# UNITED STATES PATENT AND TRADEMARK OFFICE

APPLICATION NO.	FILING DATE	FIRST NAMED INVENTOR	ATTORNEY DOCKET NO.	CONFIRMATION NO.
10/604,270	07/08/2003	Chuen-Ru Lee	9173-US-PA	1269
31561	7590	12/14/2006	EXAMINER	
JIANQ CHYUN INTELLECTUAL PROPERTY OFFICE 7 FLOOR-1, NO. 100 ROOSEVELT ROAD, SECTION 2 TAIPEI, 100 TAIWAN			JONES, HUGH M	
			ART UNIT	PAPER NUMBER
			2128	
DATE MAILED: 12/14/2006

<b>Office Action Summary</b>	<b>Application No.</b>		<b>Applicant(s)</b>	
	10/604,270		LEE ET AL.	
	<b>Examiner</b>		<b>Art Unit</b>	
	Hugh Jones		2128

### DETAILED ACTION

Cross-sectional view of a typical display.

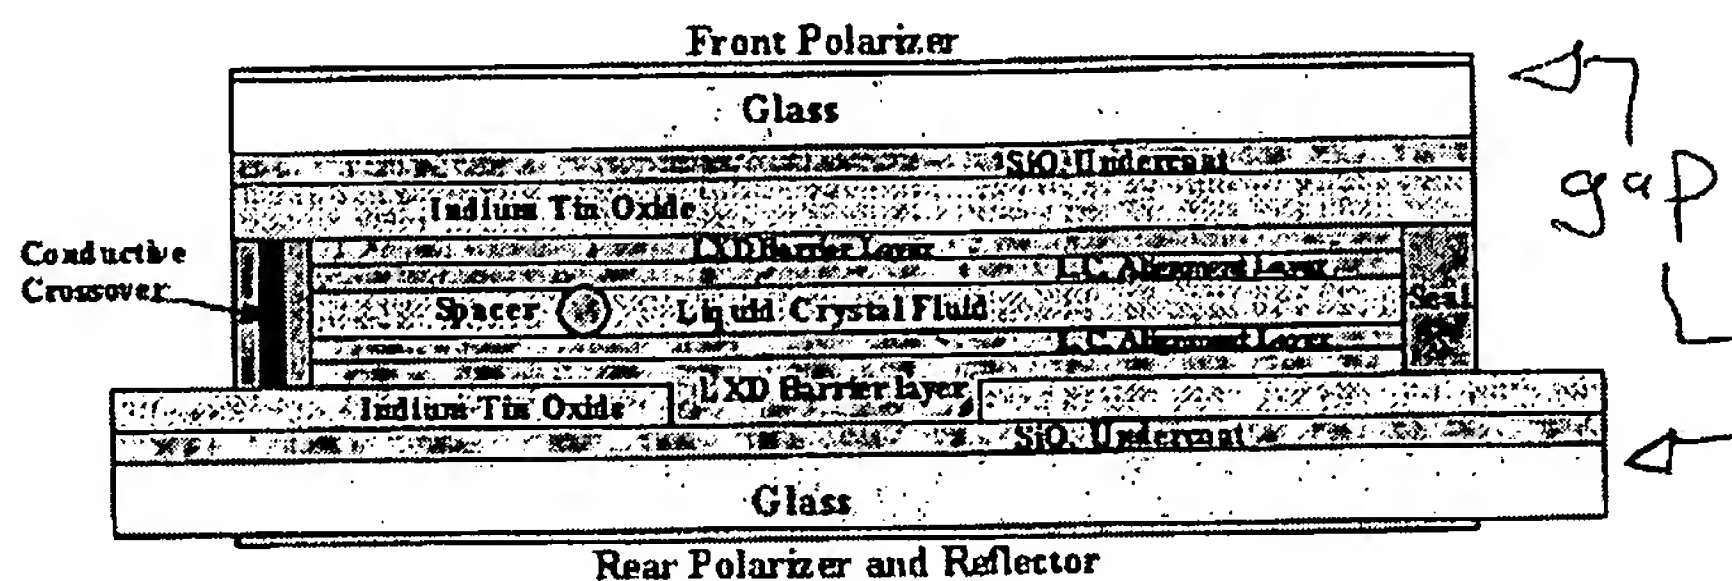
35. Applicants are thanked for their explanation on pages 10-13. However, respectfully, the meaning of cell gap is still not understood. On the one hand, Applicant's argue about adjacent cells (page 9). Applicants also argue (page 9) that the term is standard in the art. On the other hand, the arguments in the middle of page 12 suggest that the cell gap may be intrinsic to a single cell. The latter definition is that as known in the art, as explained in the last office action. See (of record):

41. However, the Examiner conducted an extensive search and does not agree with Applicant's conclusion. Cell gap, in the prior art, refers to the geometry of an individual cell, and not the distance between cells. Applicants have provided no evidence in support of their conclusion.
